Strathcona Gardens Rec-Reate Aquatic Centre & Renovations **ADDENDUM #4**

Date: March 28, 2024

ARCHITECTURAL TENDER ADDENDUM #4

This addendum revises the Tender Documents for Strathcona Gardens REC-REATE issued for tender February 2, 2024.

A901.2

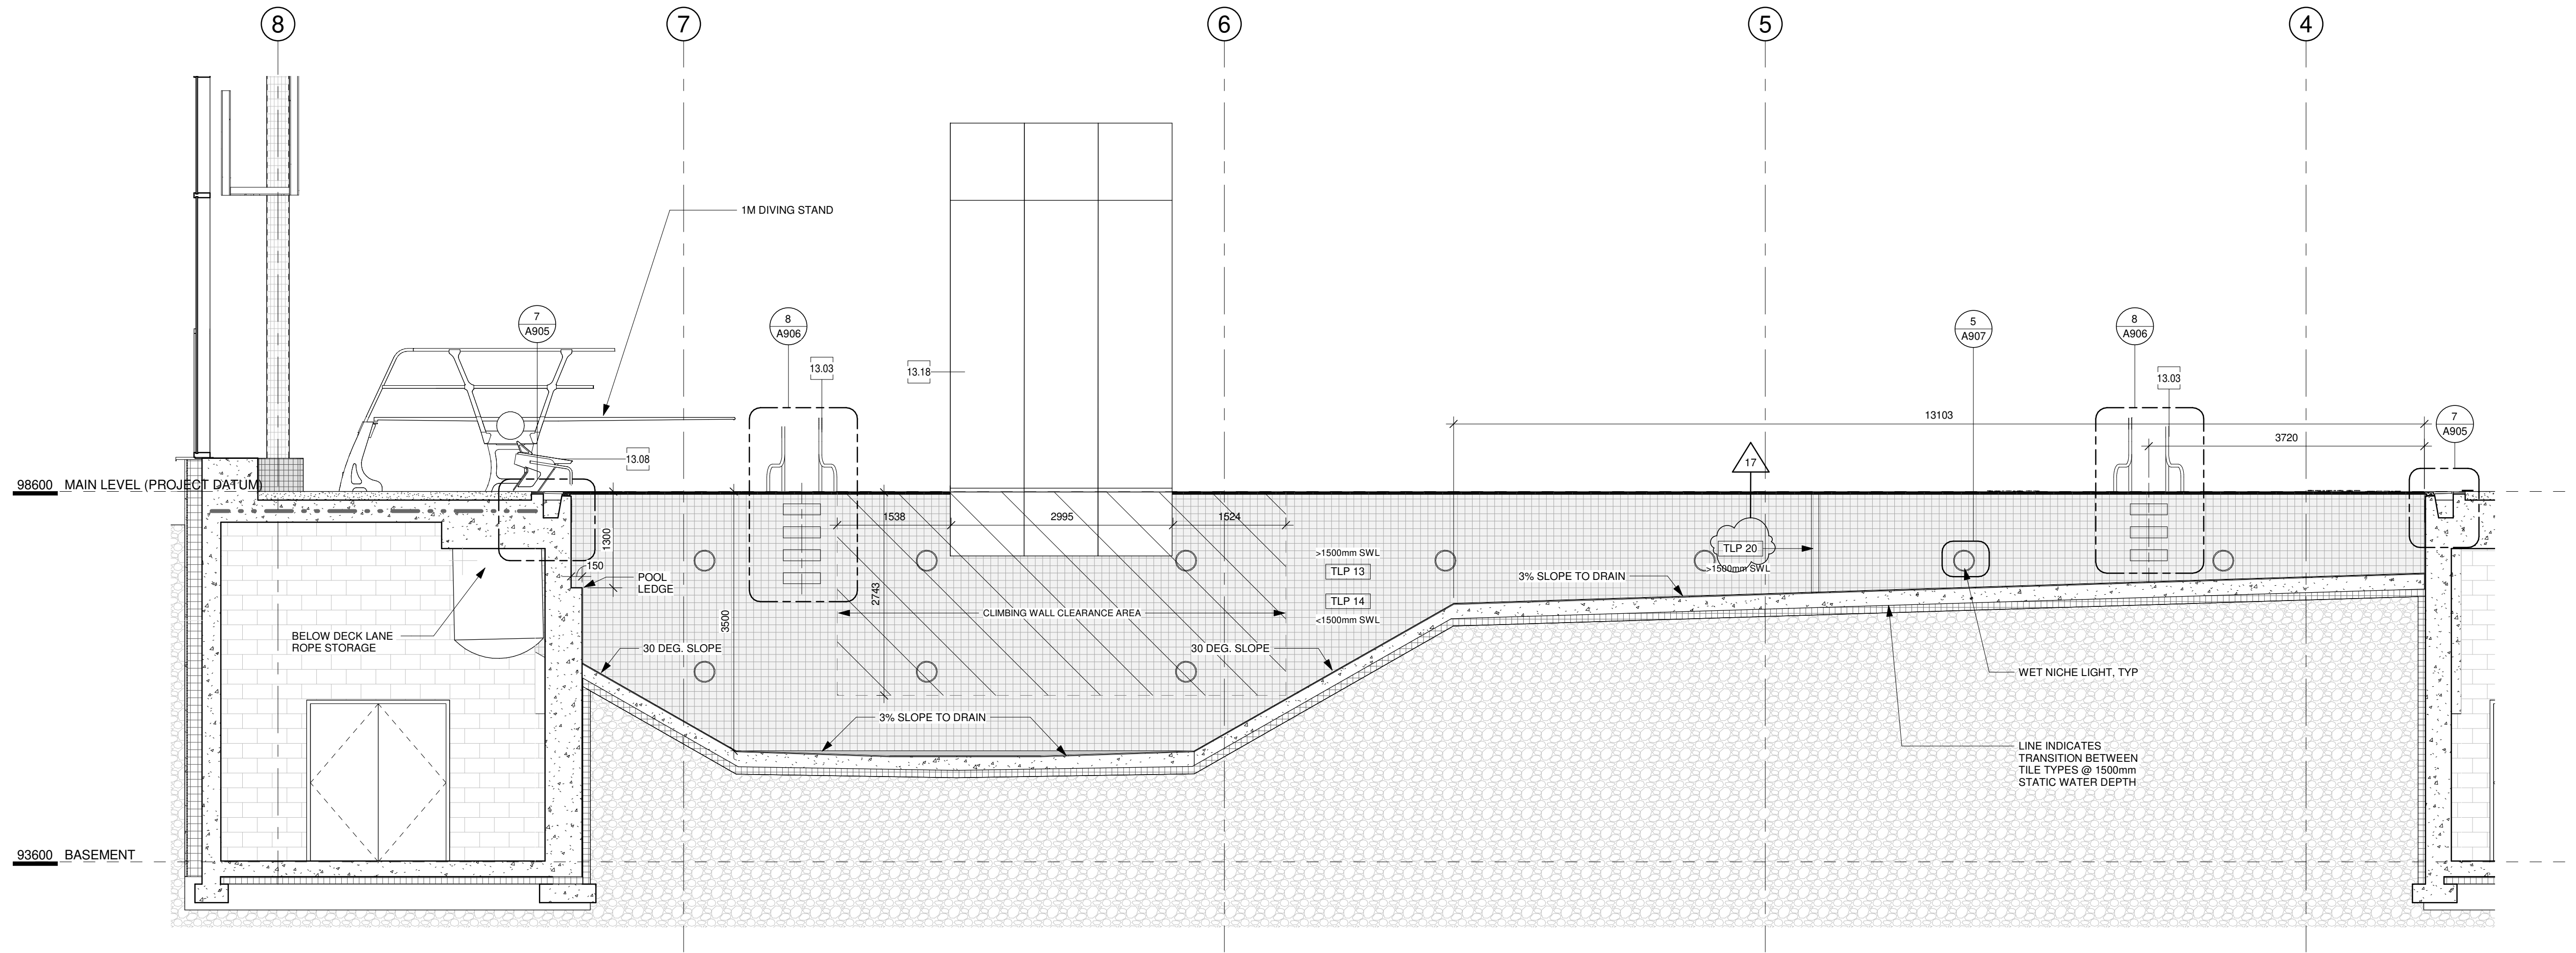
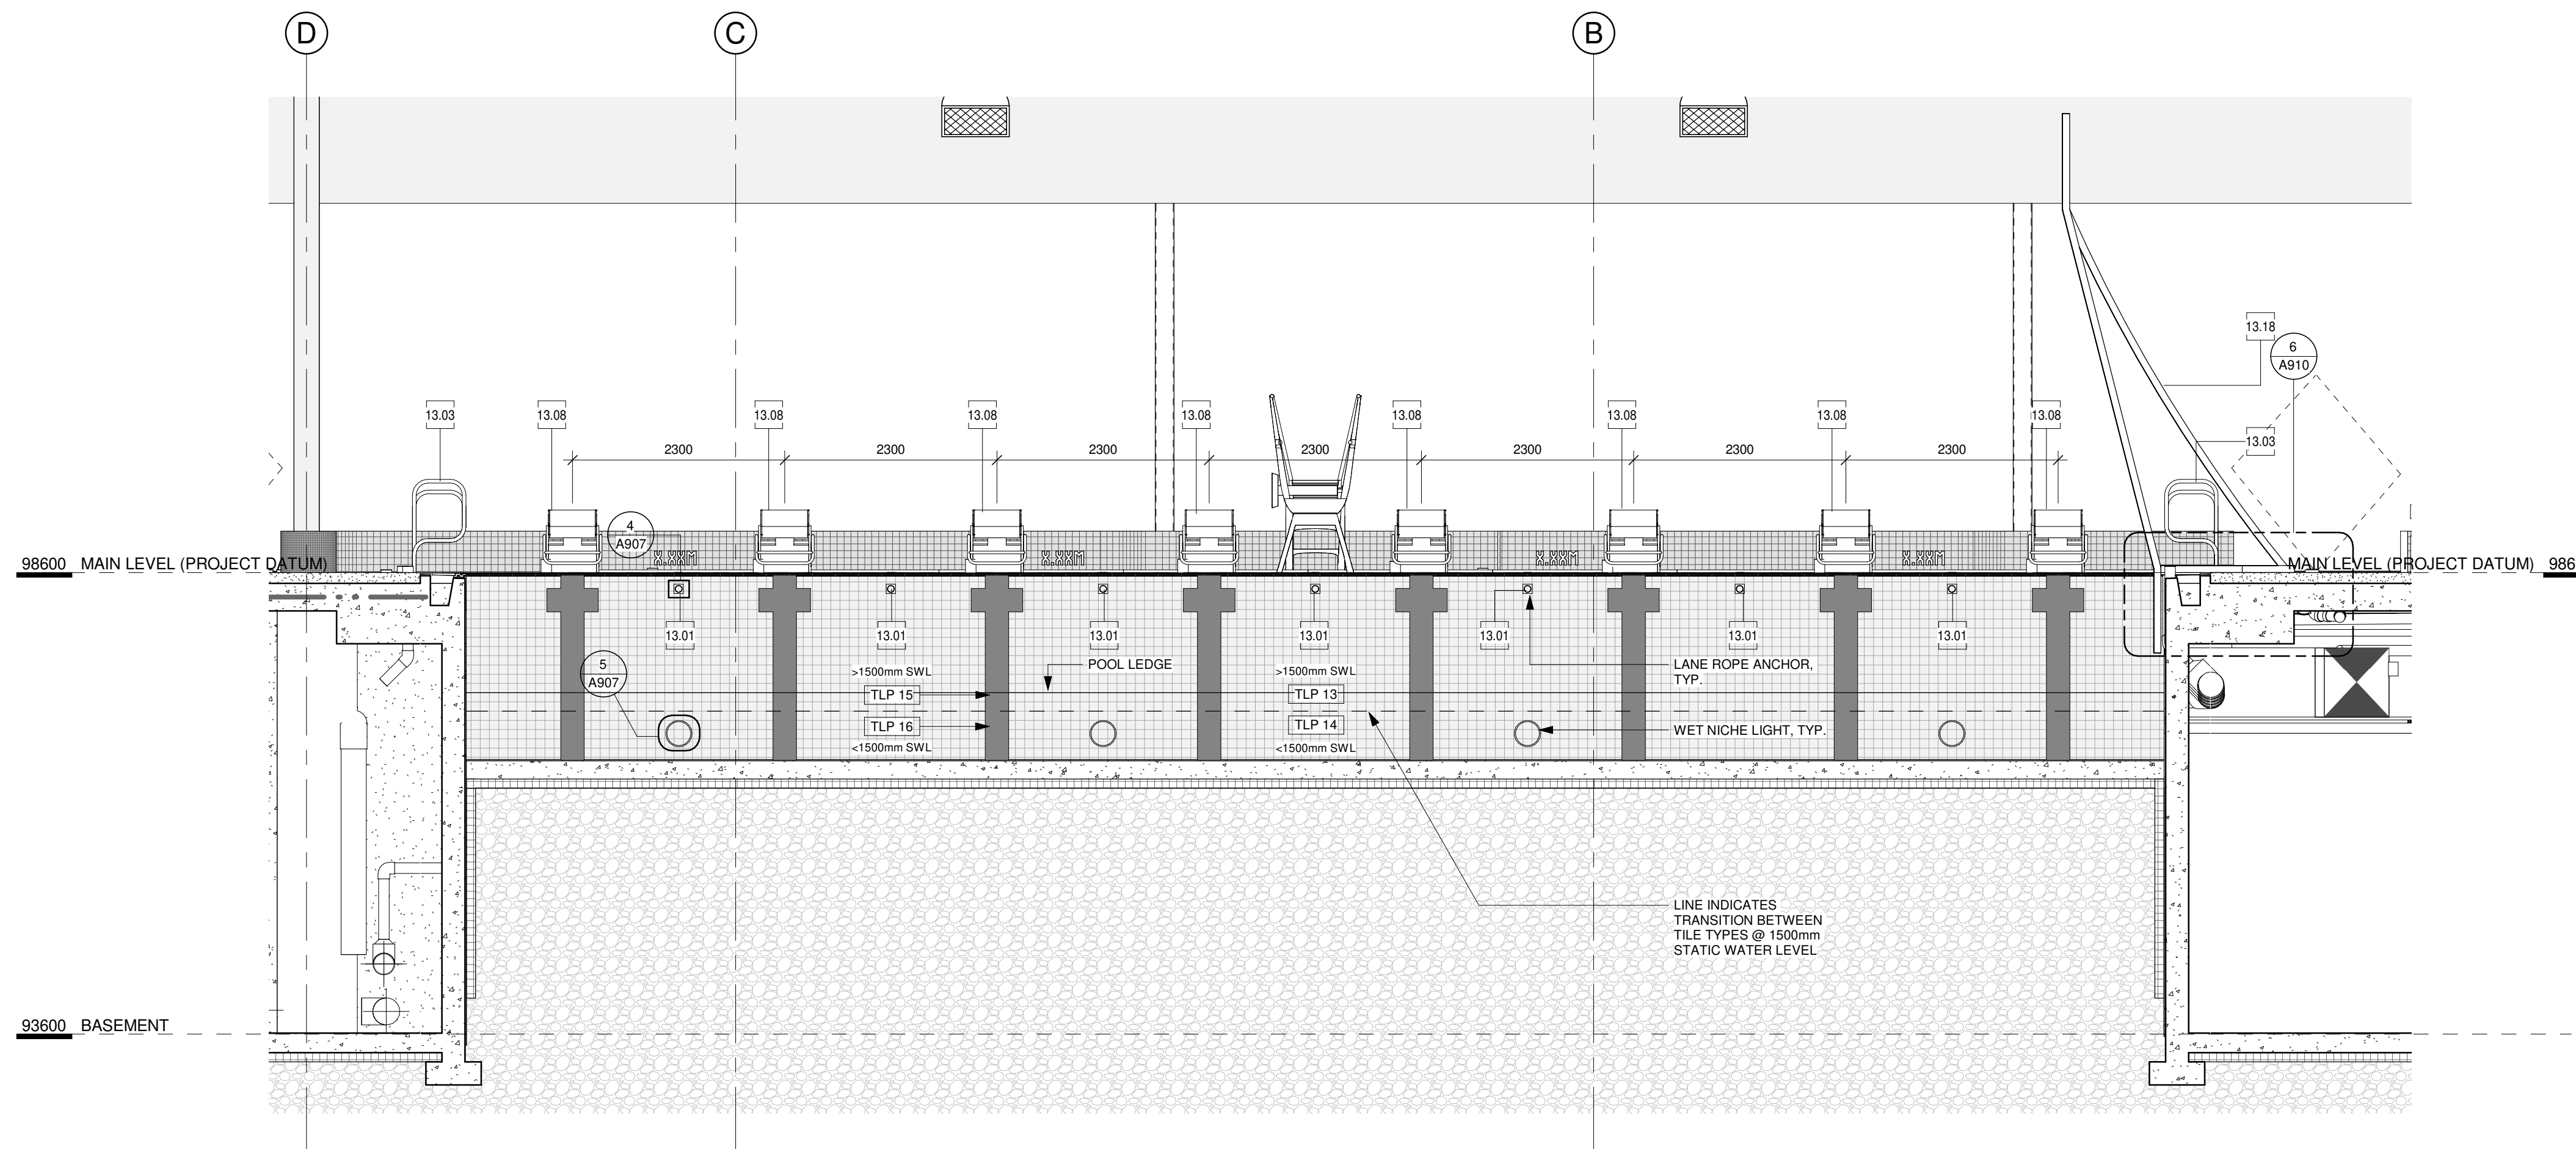
1. REVISE: Lap pool safety tile type.
